NAME	DATE	MASSACHUSETTS INSTITUTE OF TECHNOLOGY CENTER FOR SPACE RESEARCH				
		DRAWN M. Doucette	03/30/04	Schematic VOILA Chestpack				
		CHECKED R.Goette	4/22/04					
85-40400		VOILA	APPROVED R.Foster	2/28/04				
NEXT ASSEMBLY		USED ON	RELEASED D.Gage	5/03/04	SIZE A	CODE IDENT NO. 80230	DRAWING NO. 85-03020.40	REV. C
APPLICATION					SCALE	SHEET 1 OF 1

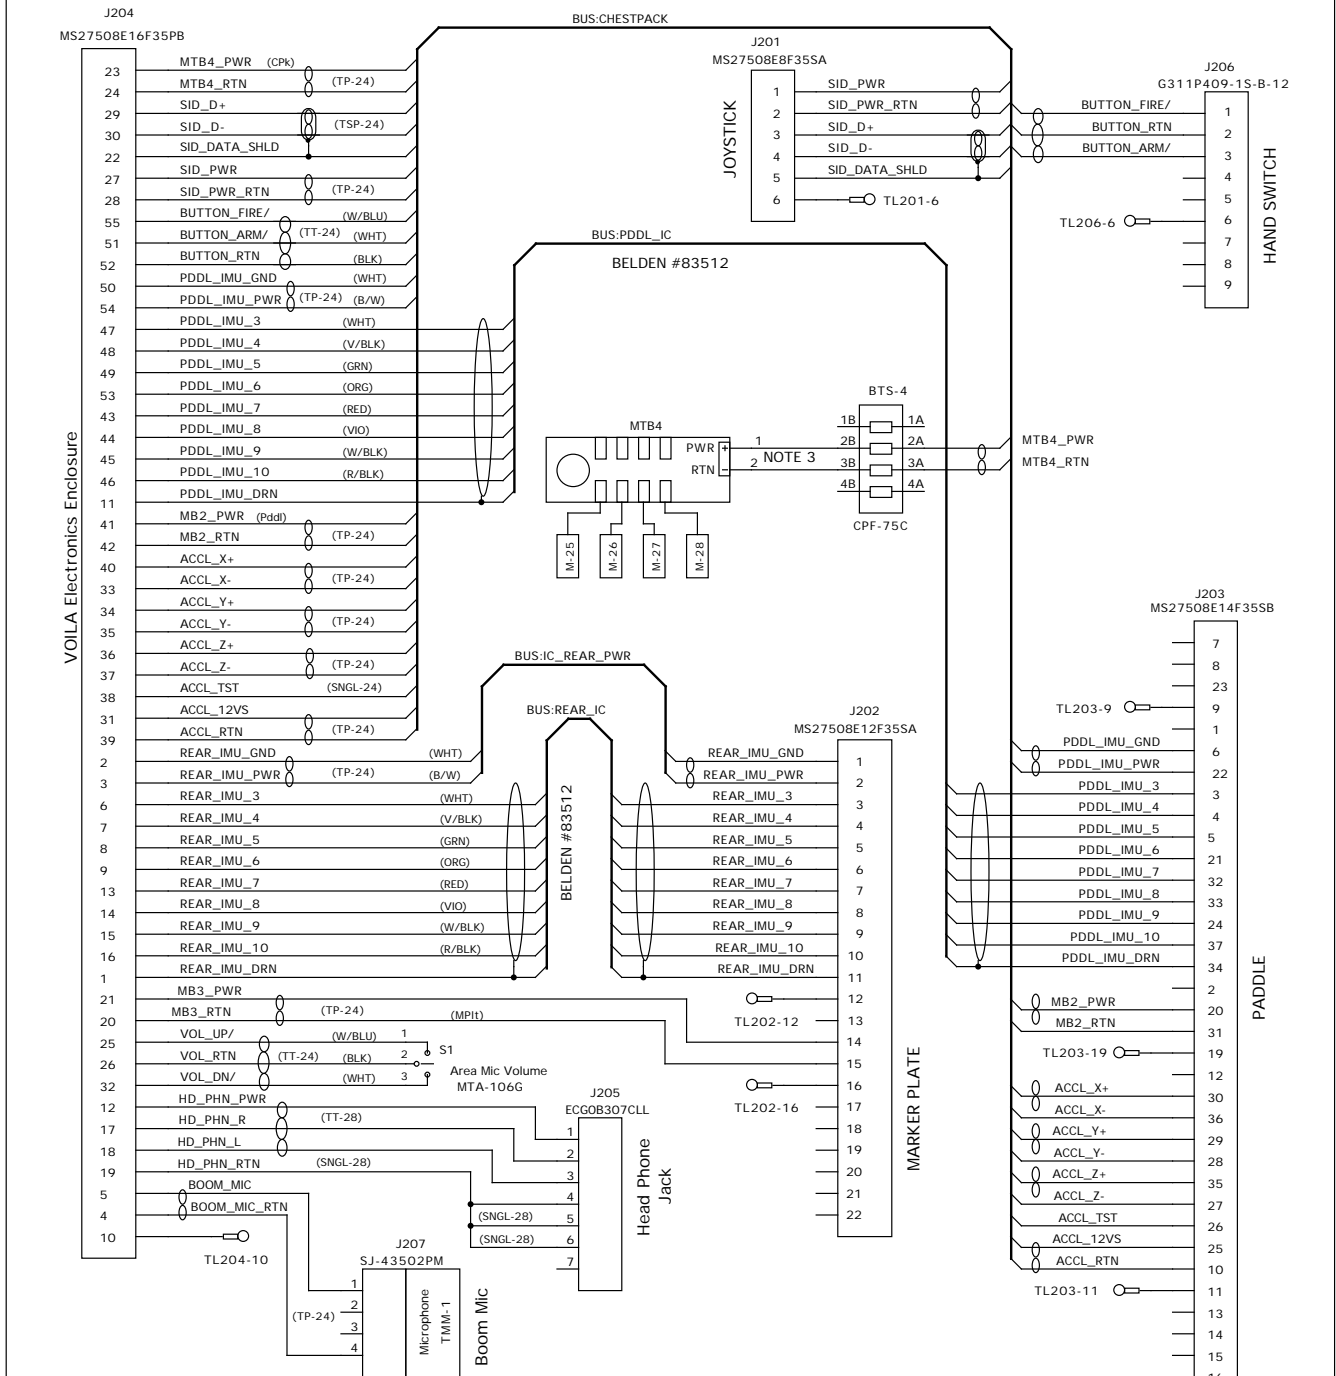
C	85-180	J203-24 was PDDL_IMU_8. Head Phone conductors were 24AWG. ACCL TP symbols paired incorrectly. IMU busses are Belden 83512. Move TL206-5 to J206-6 & rename TL206-6. Add BTS-4. Add Note 3.	RGF	RF	1/5/05
---	--------	--	-----	----	--------

REVISIONS					
REV.	ECO NO.	DESCRIPTION	CHECKED	APPROVED	DATE
A	85-090	Initial Release	RGF	RF	4/28/04
B	85-146	Add Head Phone POWER, MkrBox power was TP22. J205 is LEMO ECG0B307C11. Fix J206 PN. Paddle & Rear IC buses are in-house fab. Add chassis GND to J202-16 & 12.	RGF	RF	9/28/04
